720 ERBSVILLE ROAD, WATERLOO, ON
ENVIRONMENTAL NOISE STUDY
REVISED SITE PLAN

NOISE PLAN OVERLAY WITH SITE PLAN

DWG JPE-1021 N-1

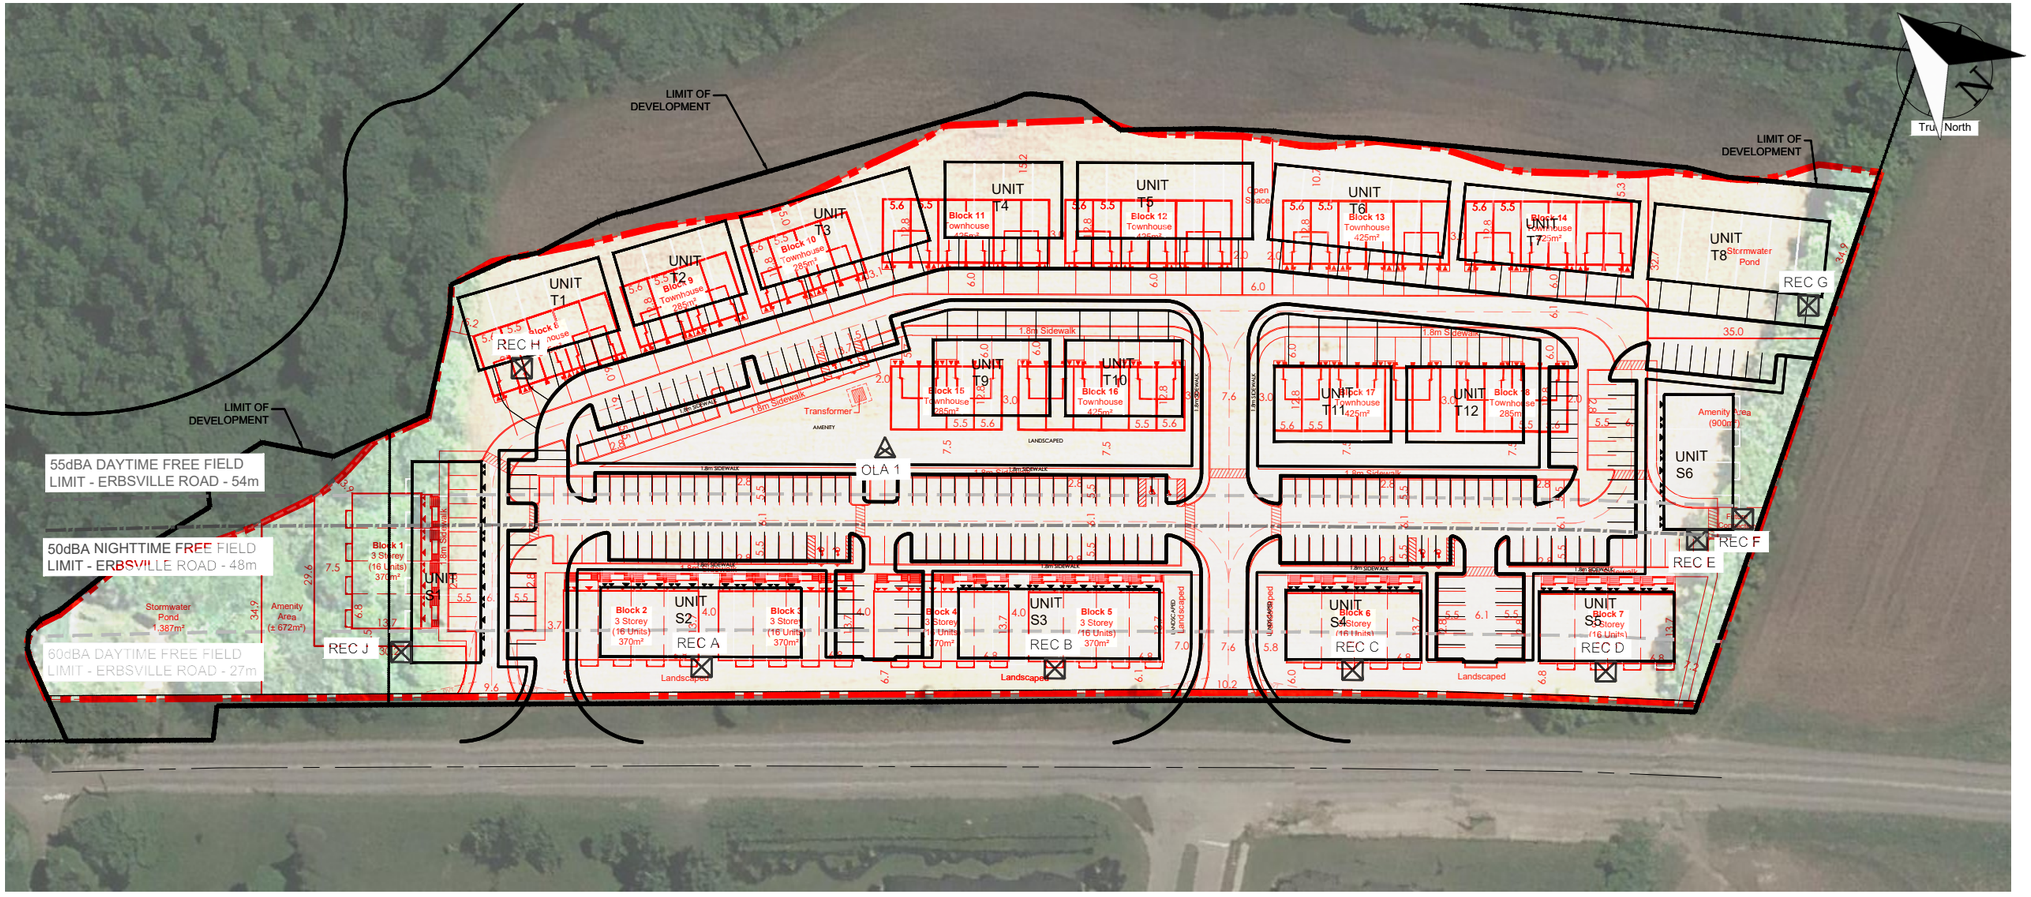
Subsequent to the October 2021 Noise Study, the proposed development's Site Plan has been modified. We have overlaid the current Site Plan (October 12, 2023) onto IBI's October 2021 Noise Information plan as attached. The red lines and text represent the current revised Site Plan, and the black lines and text, and aerial photo represents the October 2021 Site Plan. From this comparison, we make the following observations:

1. The setbacks from Erbsville Road (the noise source) to the adjacent critical (most exposed) residential receivers has not significantly changed for many (i.e., Receivers A, B, C, and D), and has increased for one (i.e., Receiver J). Thus, the noise levels for the receivers on the revised Site Plan will remain unchanged or will be reduced from that reported in the October 2021 study.

2. The setback from Erbsville Road (the noise source) to the development's outdoor amenity area (i.e., OLA 1) has not significantly changed and thus the noise level will be the same.

3. The buildings flanking Erbsville Road provide a partial barrier for noise to the interior of the development. While the IBI study did not account for this screening of noise, it is noted that the building flankage has increased from 57% to 67% of the residential frontage (i.e., not including the SWM pond). Thus, the revised Site Plan will generally have reduced noise levels at the interior receivers compared with the October 2021 Site Plan.

Accordingly, we conclude that the analysis and findings of the October 2021 Noise Report remain valid for the revised Site Plan, and thus that report's recommendations remain unchanged for the revised Site Plan.

We recommend that a revised Noise Report is not needed at this functional stage of the development's planning and design. If required, a final Noise Study could be prepared during the Site Plan Approval stage of the project to ensure no other noise mitigation is warranted.
